MIDWEST POOLED FUND PROGRAM

Progress Report - Second Quarter 2009 April 1st to June 30th

Pooled Fund Consulting Summary

Midwest Roadside Safety Facility
April 2009– July 2009

Figure 2. NDOR Concrete Bridge Rail

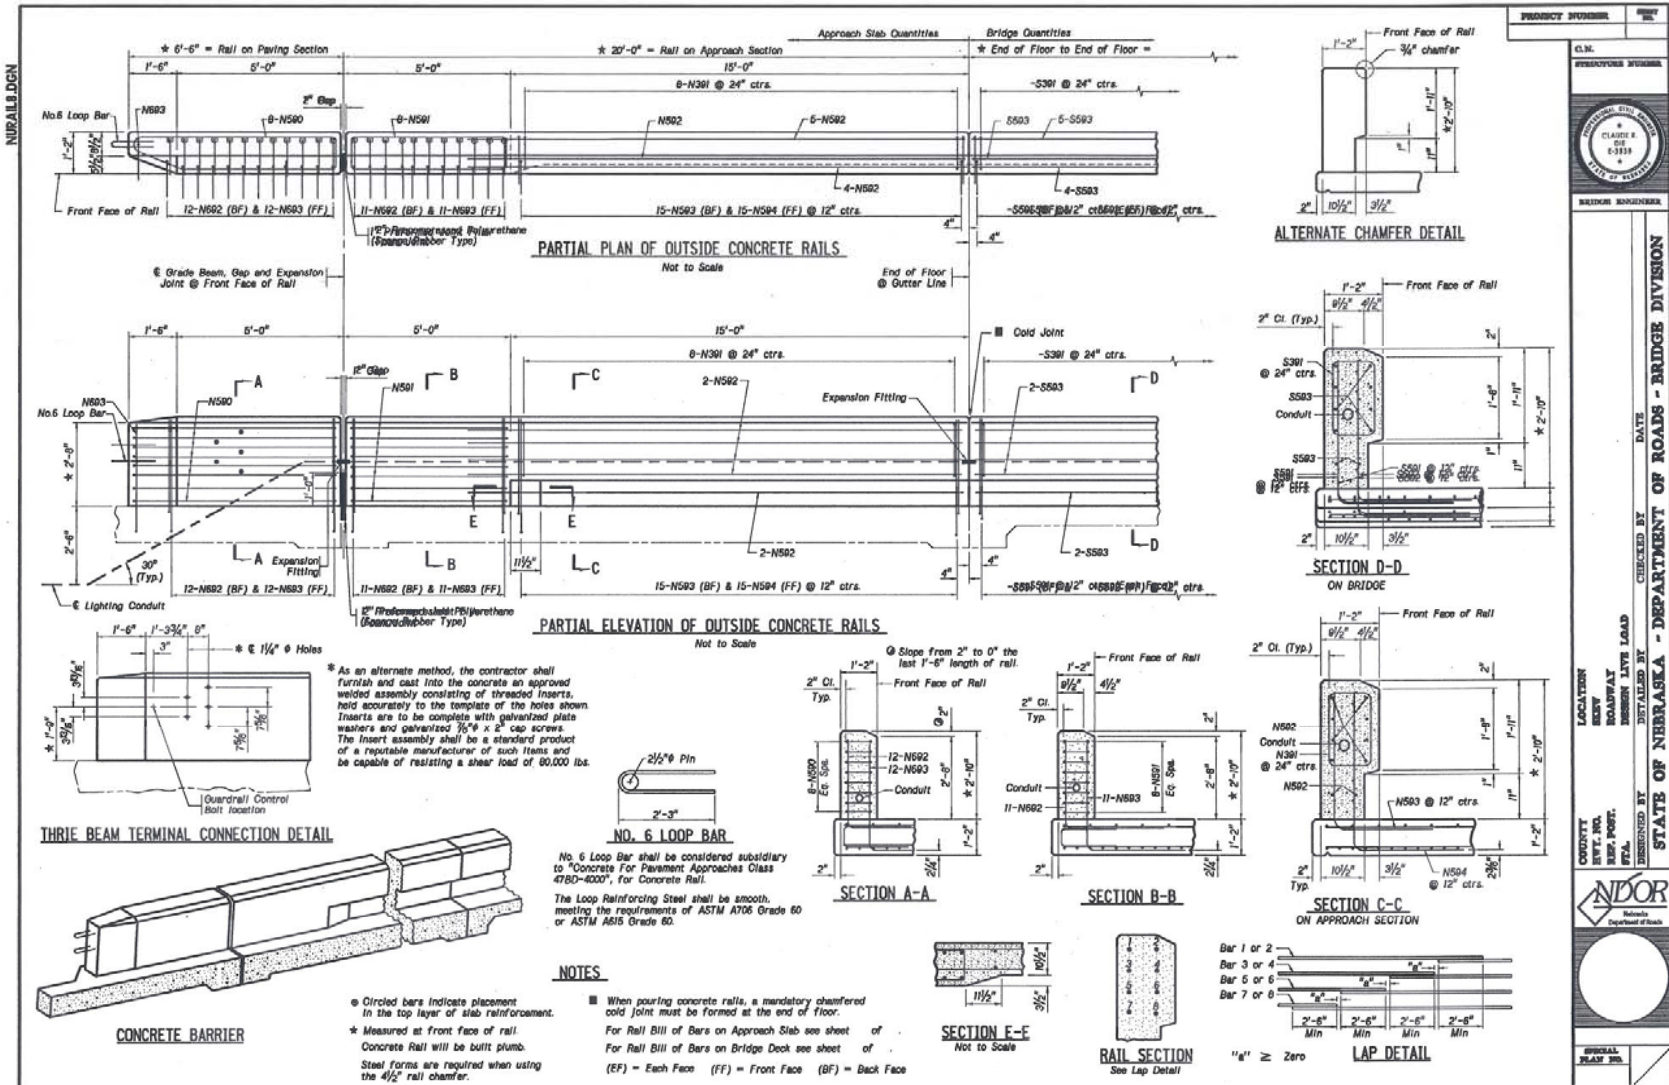
When we cross an expansion joint in a bridge and leave a gap in the bridge rail, what is the largest gap we can leave without considering it a snag point?

The rails are flush with each other, flat faced, and continue for several feet.

Should we allow 3" or a little more?

What width of gap is still acceptable?

Has there been testing to prove a snag or not?

Many years ago, MwRSF conducted AASHTO PL-1 and PL-2 full-scale crash testing on NDOR's open concrete bridge railing. For this testing program, impacts were performed both at interior sections as well as upstream of an expansion gap. The expansion gap was 4.5" and utilized chamfered edges. The impact angles ranged from 15 to 20 degrees. Although vehicle snag occurred at the downstream exposed edges, it was not sufficient to cause a failure of the tests.

Under the current testing criteria, pickup truck testing is performed at 25 degrees. For the future MASH testing, the impact angle for both the small cars and pickup trucks is 25 degrees. As such, a slight increase in vehicle snag could occur due to the increase in impact angle. Therefore, I would be more inclined to keep the gap width to a maximum of 4". In addition, it is recommended that the edges of the railing at the gap locations be chamfered in order to reduce the propensity for vehicle snag.

Figure 3. ILDOT Post and Blockout Hole Locations

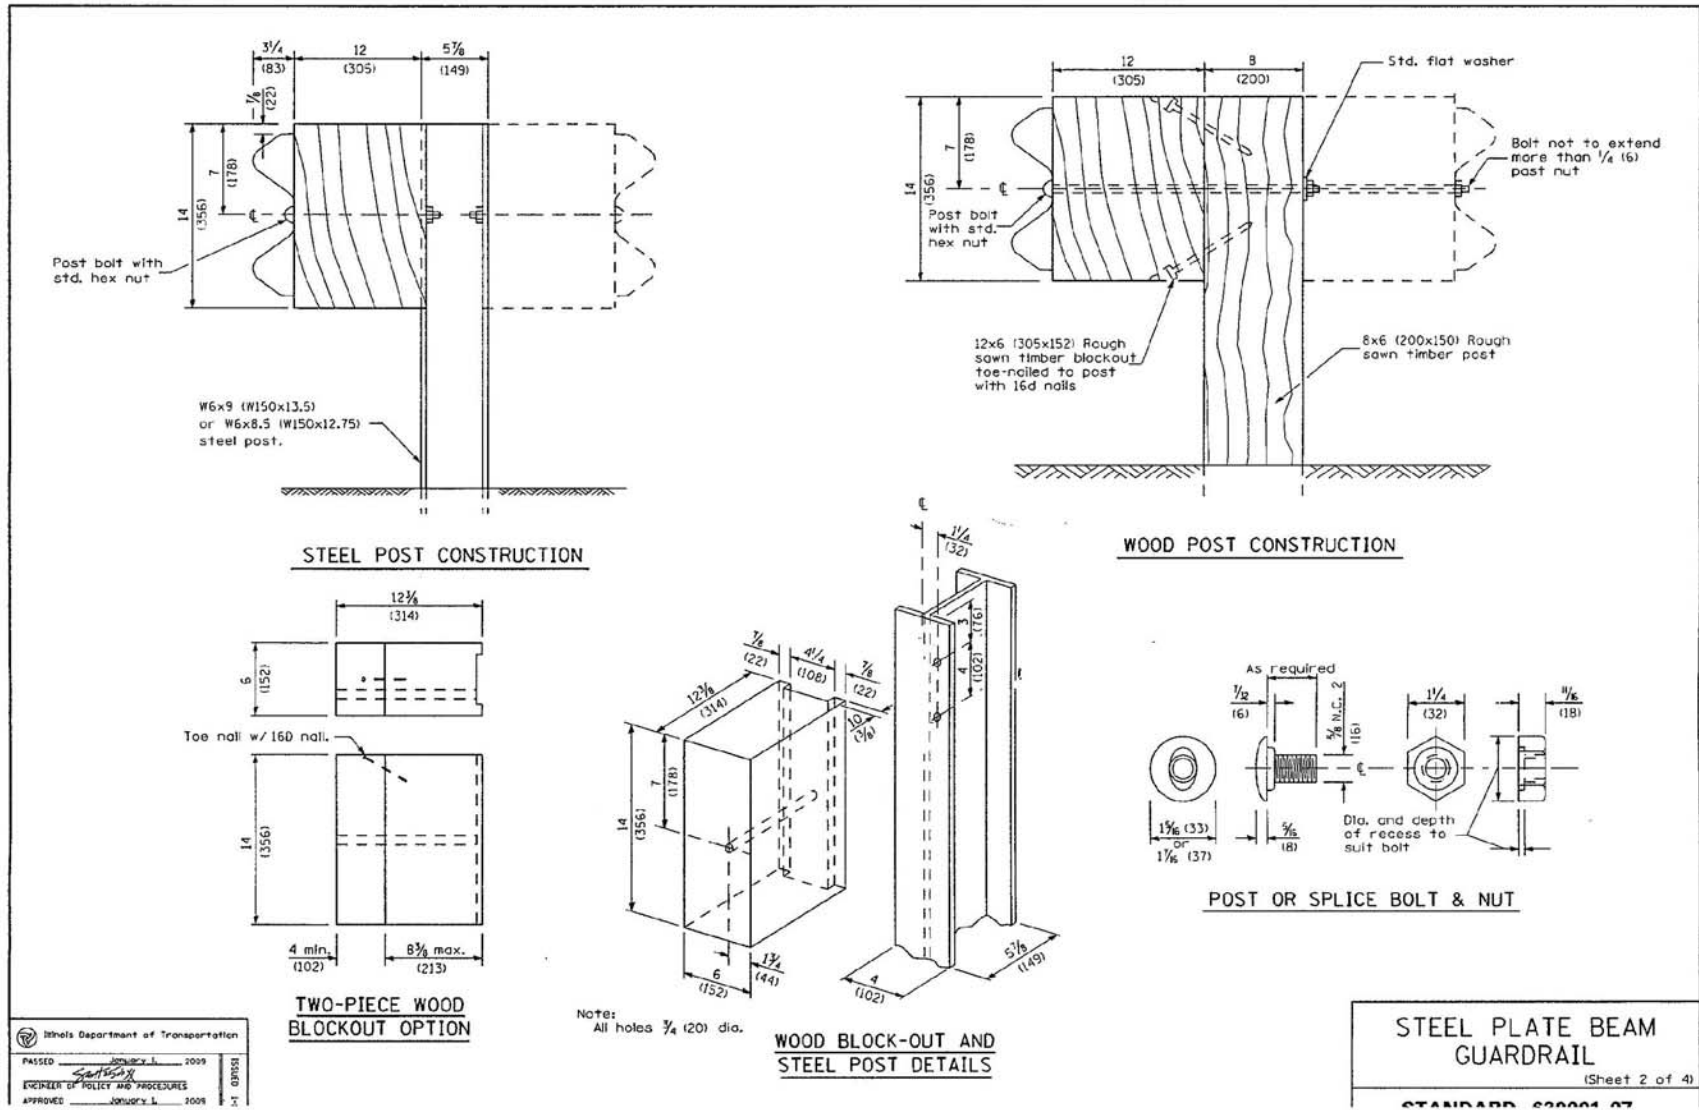
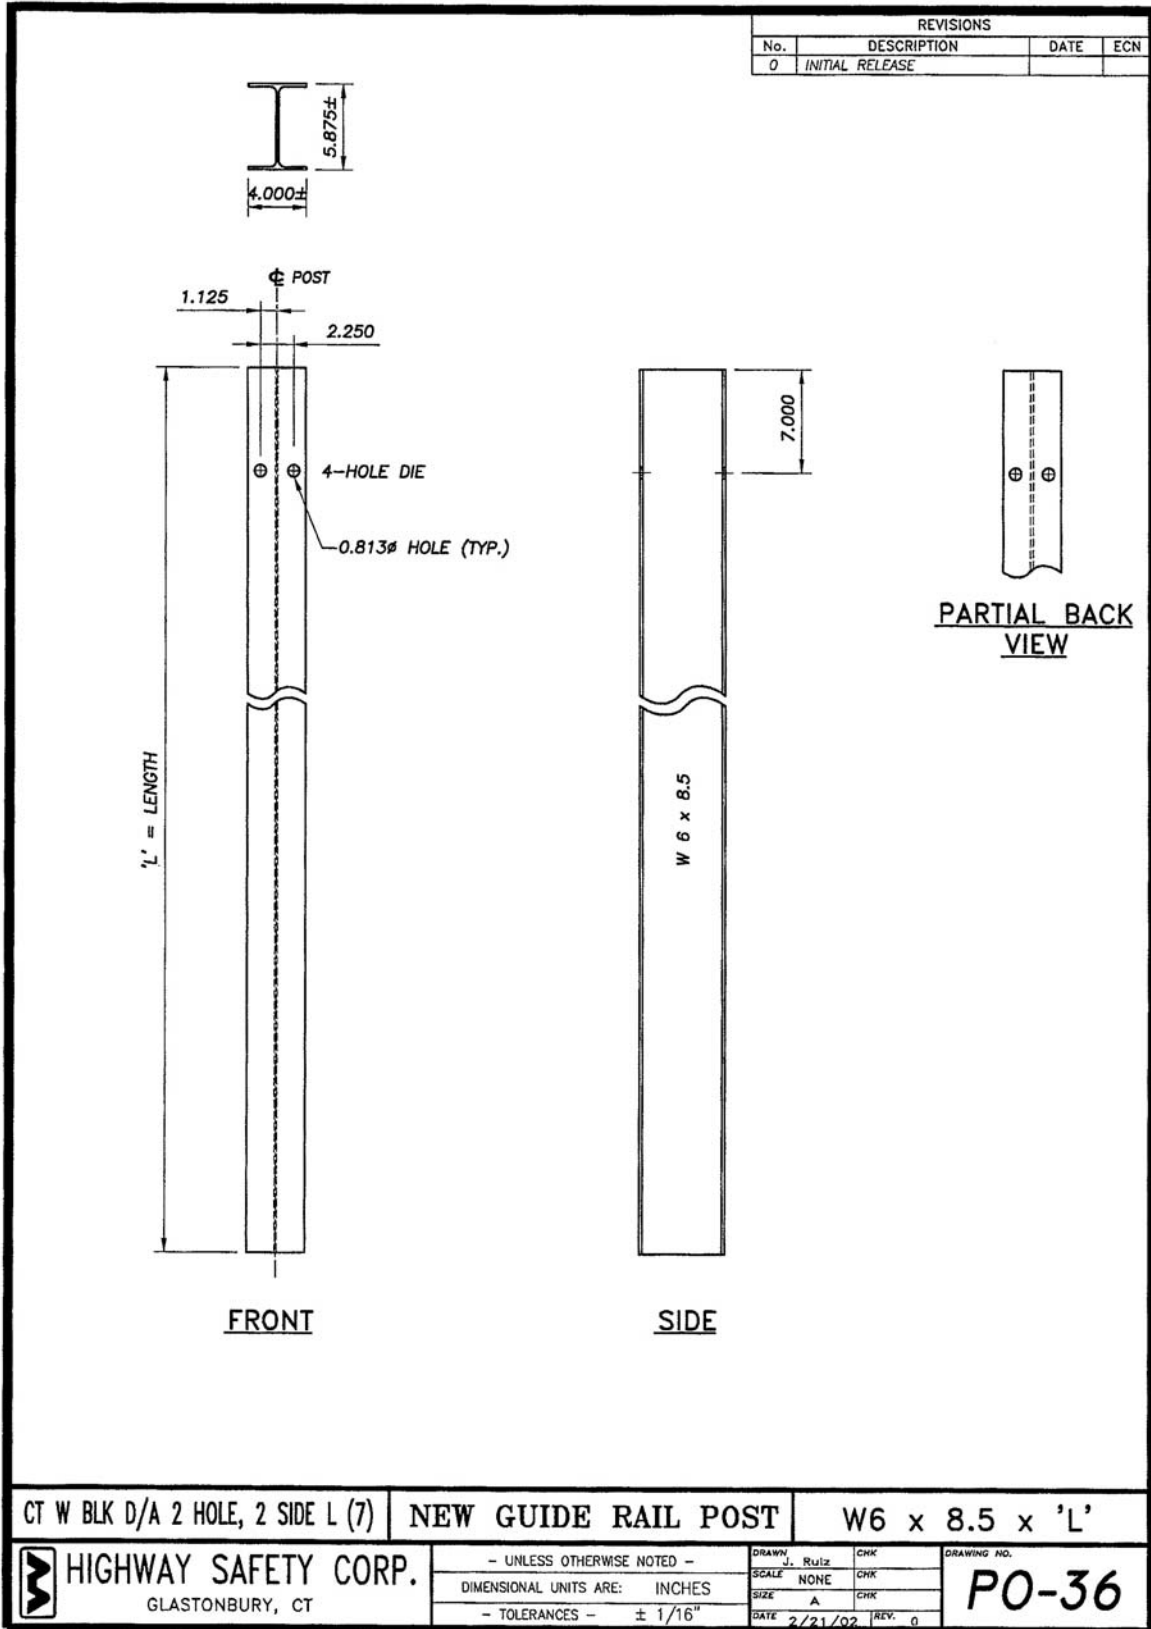
I have a question (below) from Gary Akin of Highway Safety Corp. He notes that the IL Standard for the MGS shows the holes in the posts offset by 1 1/4" horizontally from the vertical centerline of the post. The AASHTO Standardized drawing, and the company drawing show this dimension as 1 1/8". I have taken a look at the drawings from the report for "Development of the Midwest Guardrail System (MGS) for Standard and Reduced Post Spacing and in Combination with Curbs" and don't find this dimension shown directly. However, the blockout consistently shows the hole as 1 11/16 from the outer edge of the 6" wide piece. This would leave 1 5/16" from the vertical centerline of the piece.

In the Fall of 2007 we had some discussion through the Pooled Fund group, and I cannot find that this issue was raised. Is this the intent to shift the hole location outward from the center of the post by 1/8" or 3/16"?

1. I would agree that there are slight discrepancies between what we have shown on our blockout, what your attached details showed, and the hardware guide. I believe that most of the confusion is due to a combination of the use of metric units in the hardware guide, the width of the flange on the W6x9 being 3.94" versus 4", and measurement of the hole from the center of the post rather than the flange edge. I will attempt to clear this up .

2. I have attached our post and blockout details for the MGS. The post has a $\frac{3}{4}$ " hole located $\frac{3}{4}$ " from the edge of the flange. This would put the hole 1.22" from the center of the post. The hardware guide details for standard w-beam guardrail posts given dimensions of 20 mm from the edge of flange and 30 mm to the center of the post. This would be 0.7874" and 1.1811", respectively. Thus, these values agree fairly well when considering that the metric conversions often rounded up to the nearest mm. Thus $\frac{3}{4}$ " in the hardware guide is listed as 20 mm. So we believe that our post details have the hole in the correct location. Our blockout details show the bolt hole 1.25" from the center of the block. This would mean that the block is not drawn perfectly centered on the post, but the 0.03" is not something we were going to quibble about.

3. The drawings you supplied show the hole as 1.25" or 1.125" from the center of the post. We believe that the 1.25" dimension is closer to the posts that we spec and tested with and is also closer to the original hardware guide details.

4. I should also note that PO-36 detail you attached shows the post bolt hole as 0.813". The hardware guide and MwRSF details show a $\frac{3}{4}$ " diameter hole.

5. We would recommend that you use posts with the hole spacing and size similar to our details.

Figure 9. Iowa Transition Design Adaptation

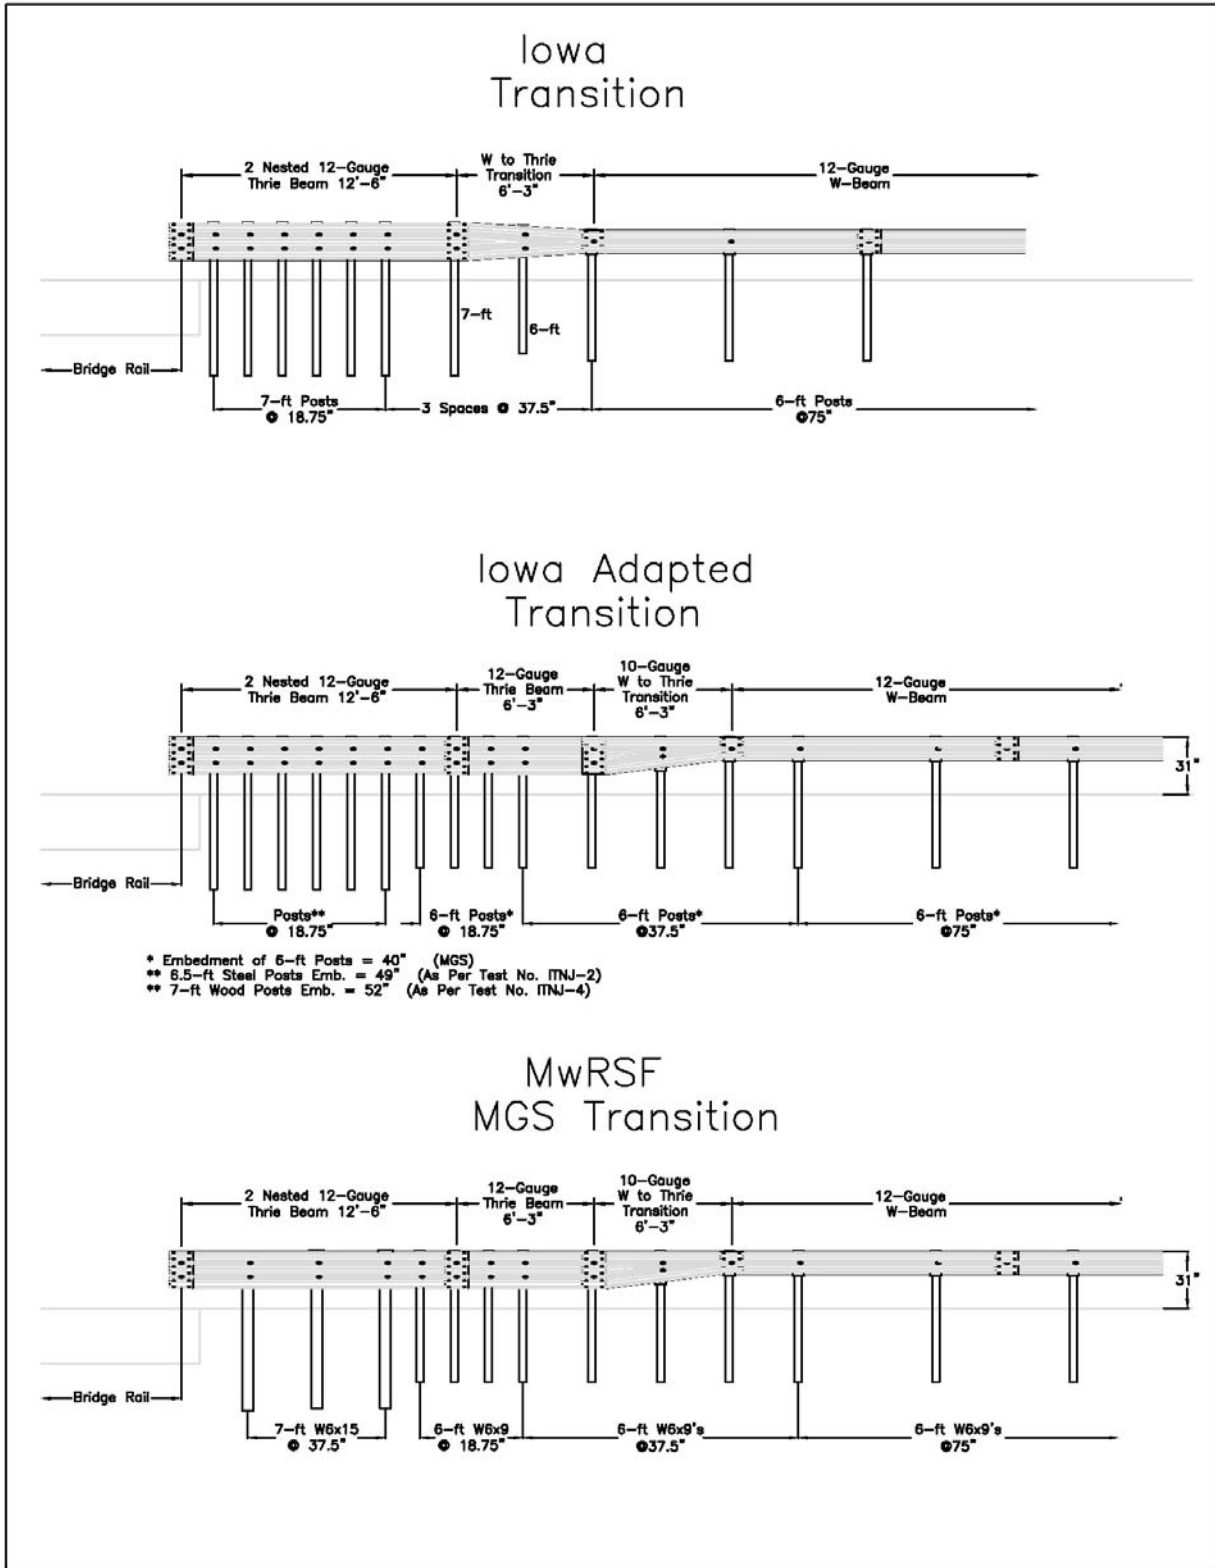
Not that Iowa is unwilling to change, but how would our current design be modified to apply the findings of your recent project? I have attached the most up-to-date version of our metric-height transition. If this becomes too complicated, we have no reservations about switching to the bigger posts and wider post spacing.
